780 BLANSHARD - REHABILITATION + ADDITION

HAV00034 CONCURRENT WITH REZ00825

Bubbled areas indicate revisions compared to the previously submitted plans

DATE	REV	ISSUE DESCRIPTION
2022-02-24	1	REZONING PRE-APPLICATION
2022-06-01	2	OPEN HOUSE PROGRESS SET
2022-06-21	3	REZONING APPLICATION
2023-03-23	4	HAP & REZONING RESUBMISSION

1 VIEW TO SITE ABOVE BEACON HILL

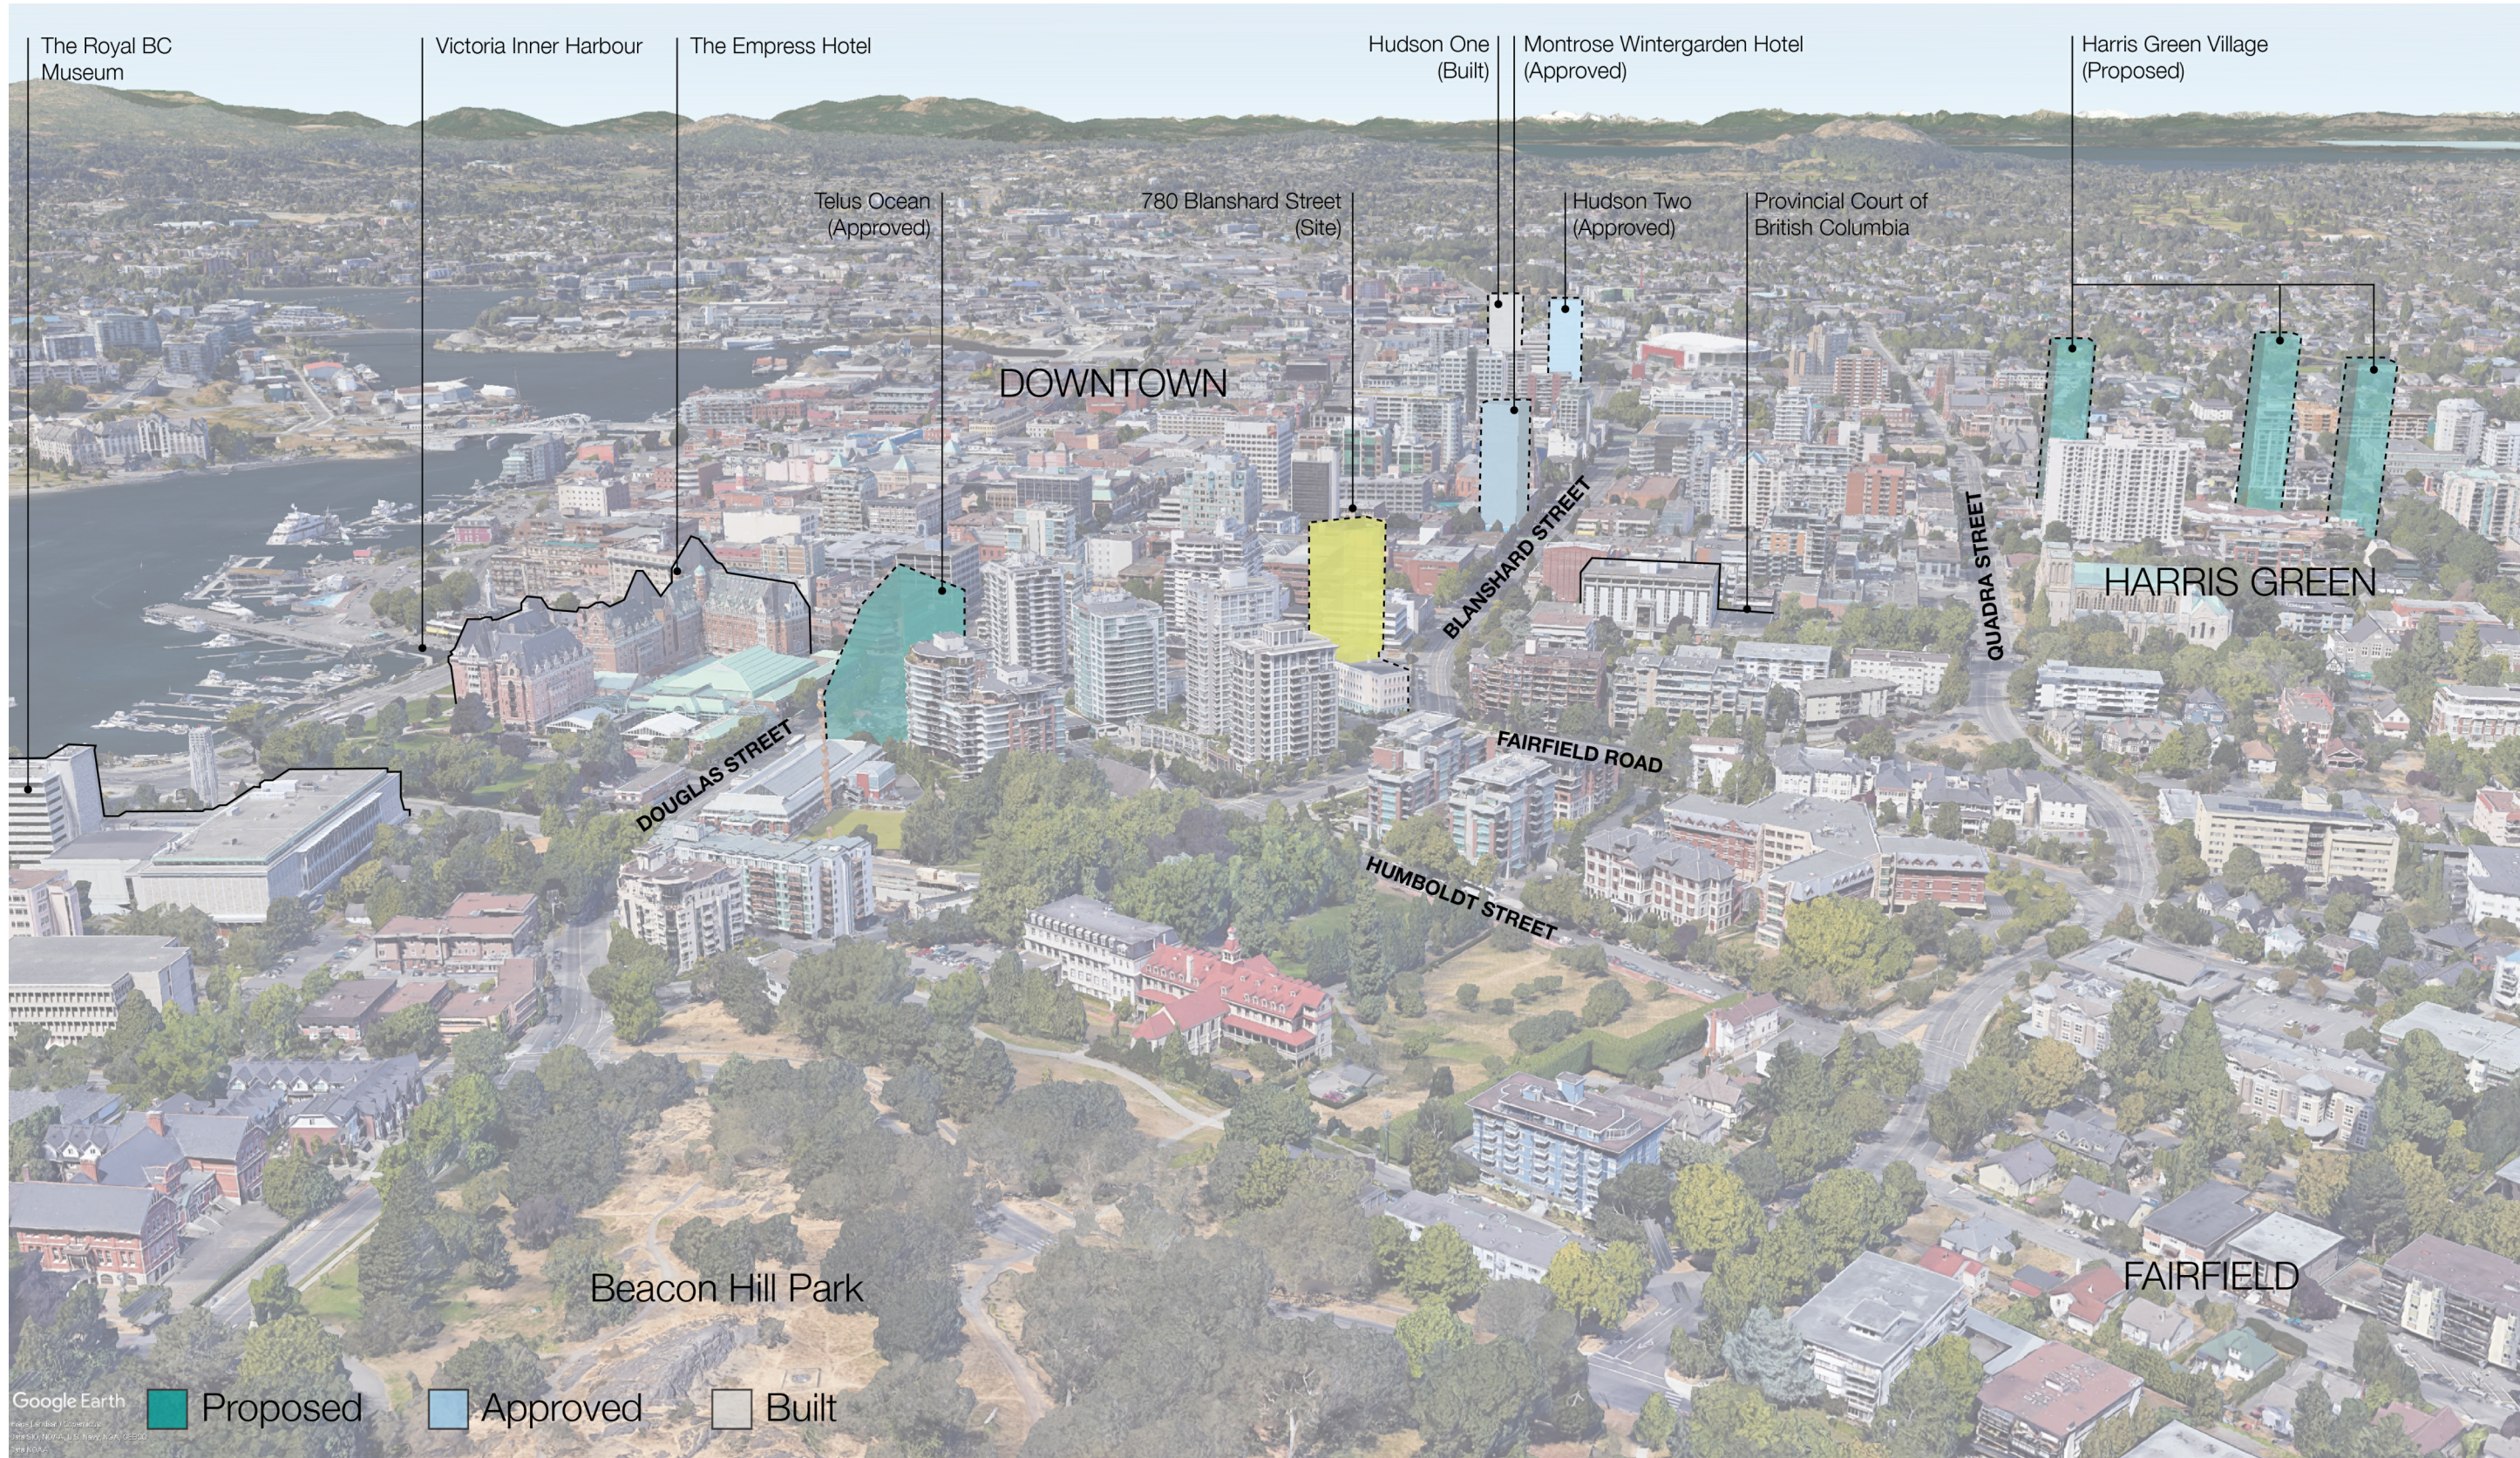
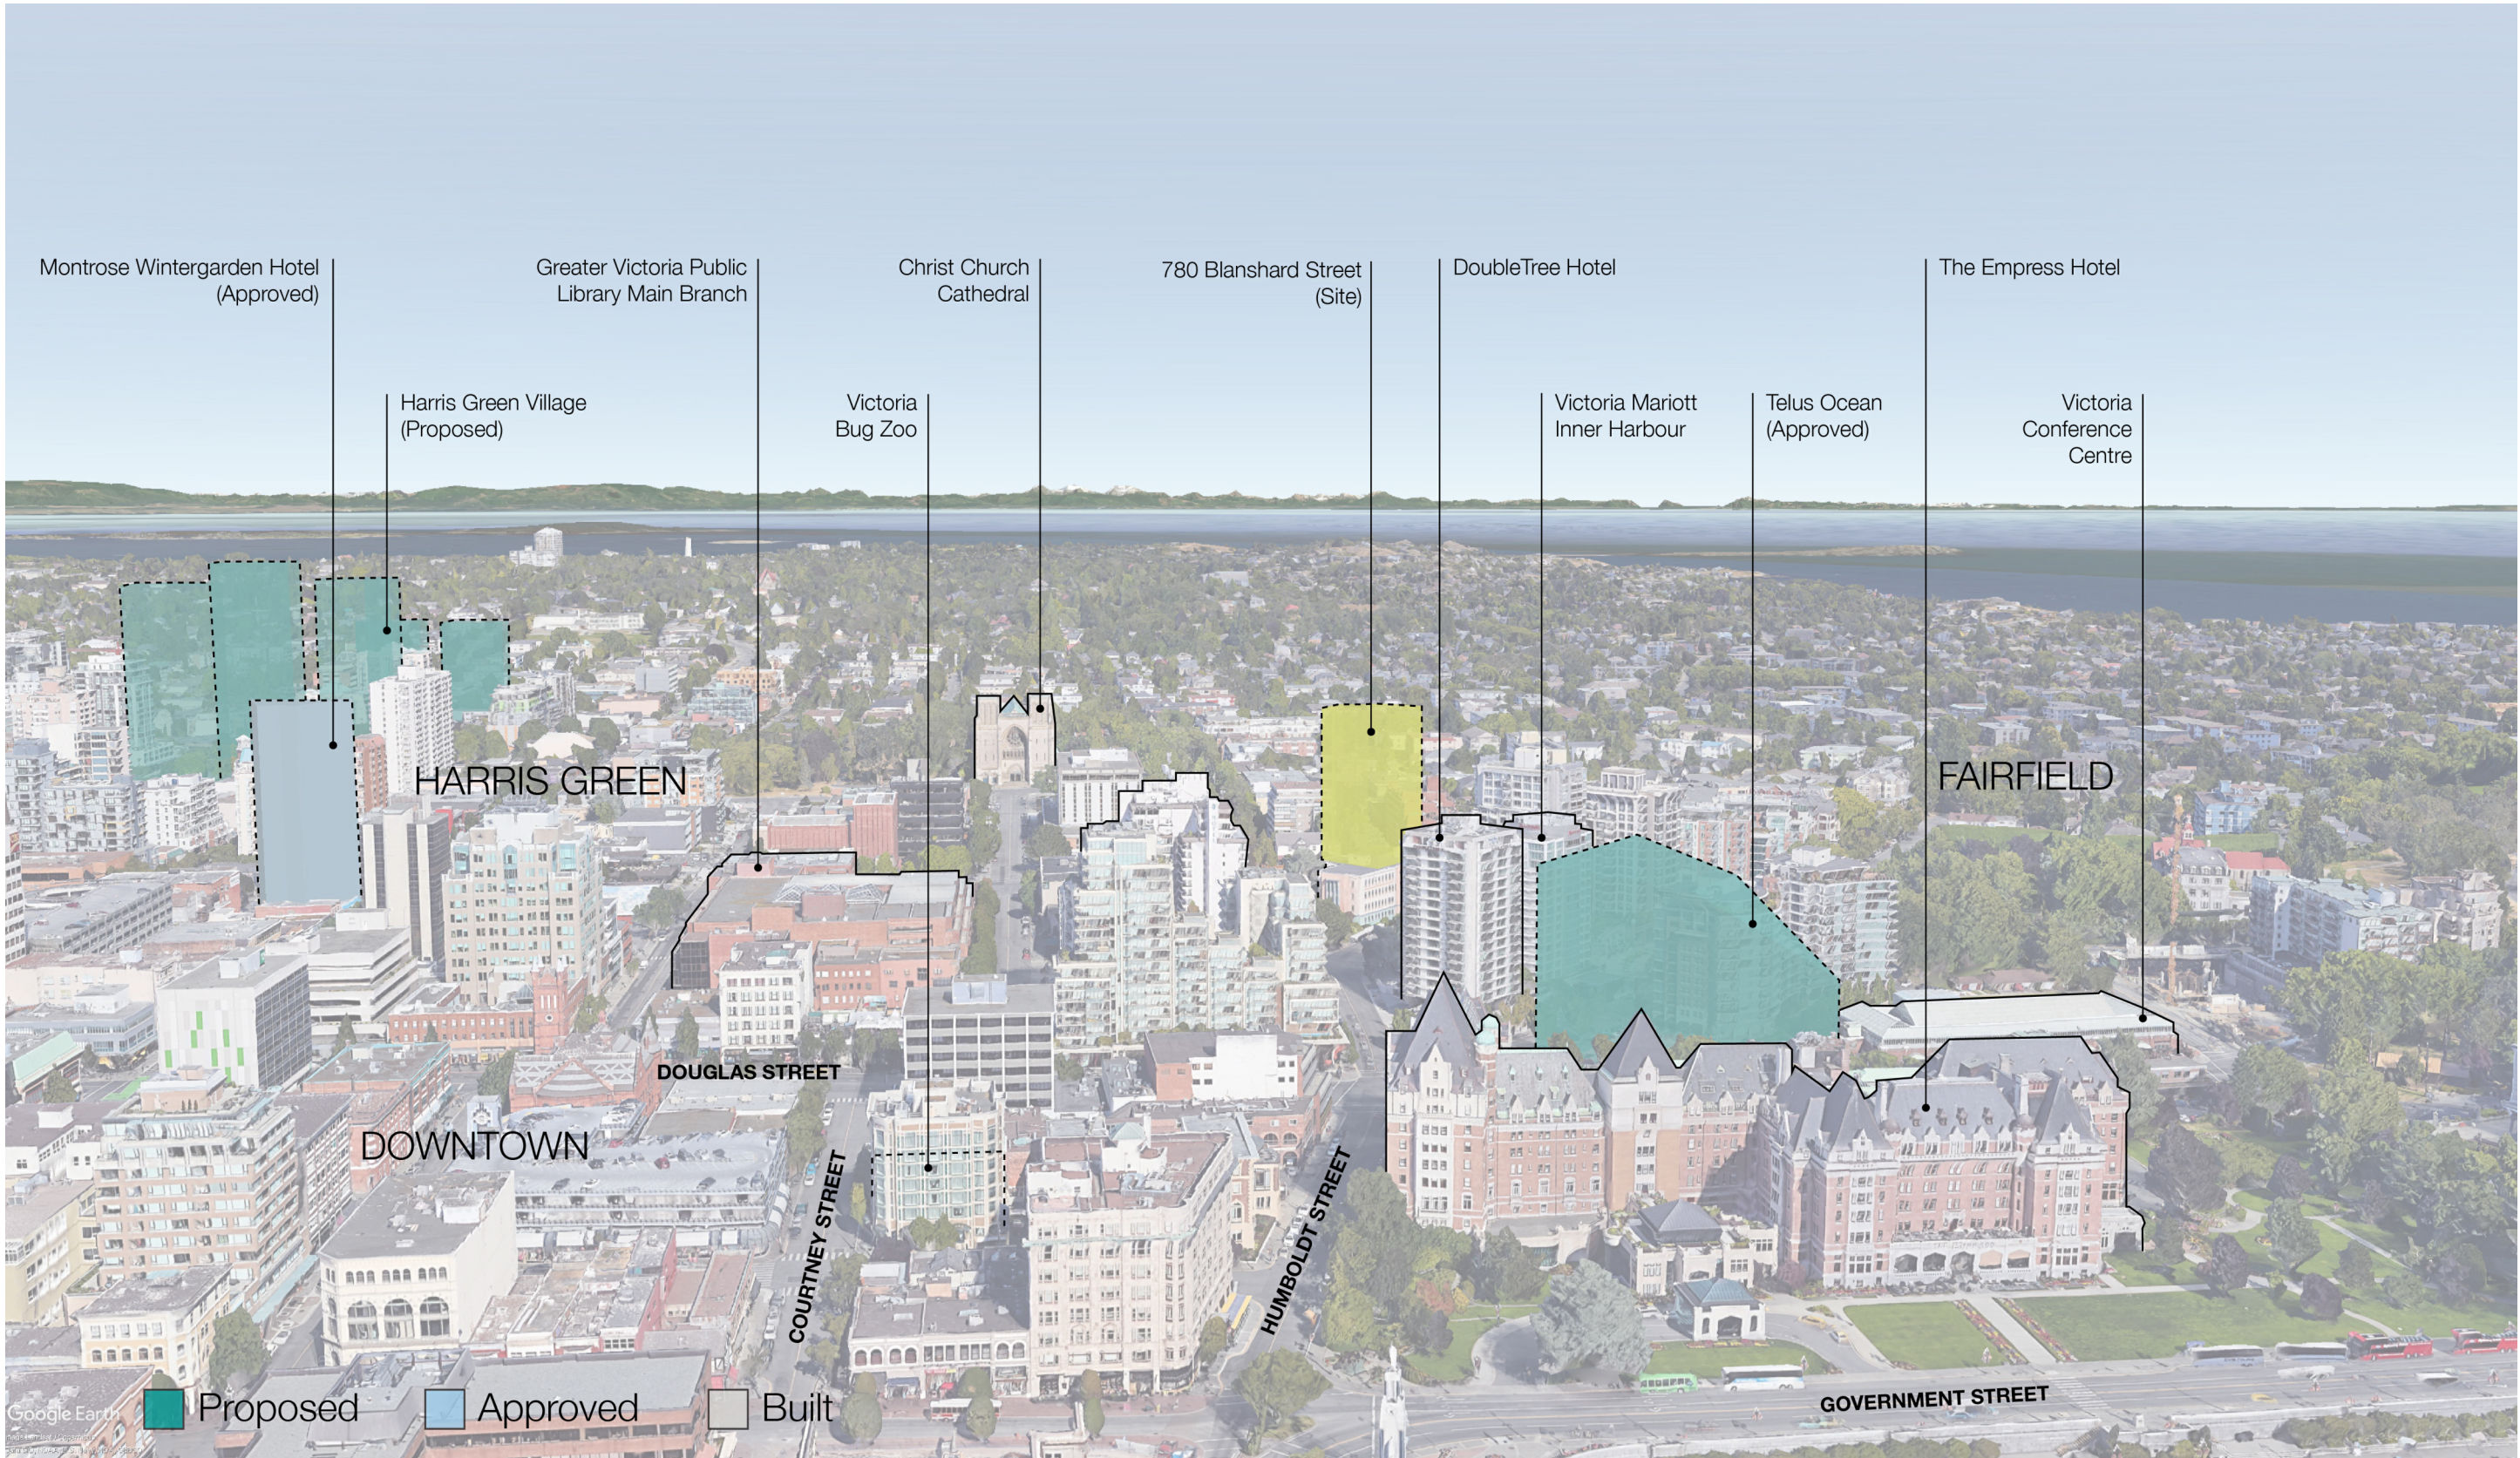
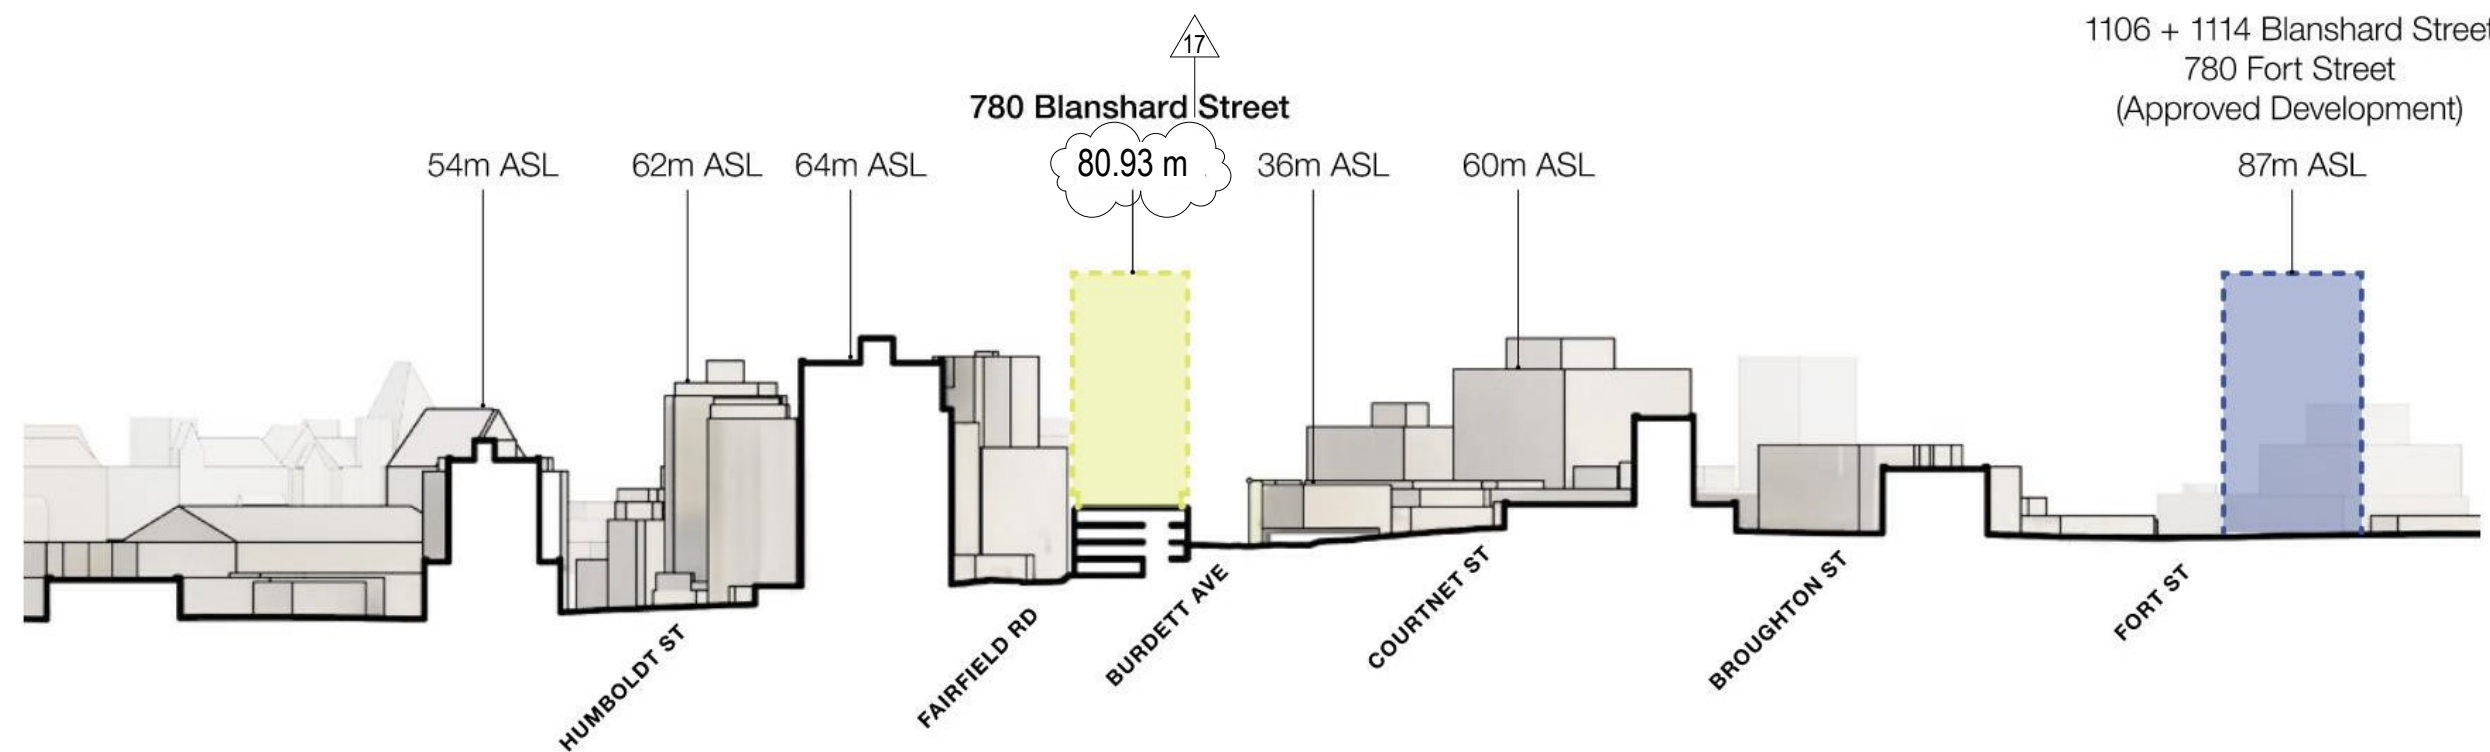
17 Updated Height per ARS comment #22.
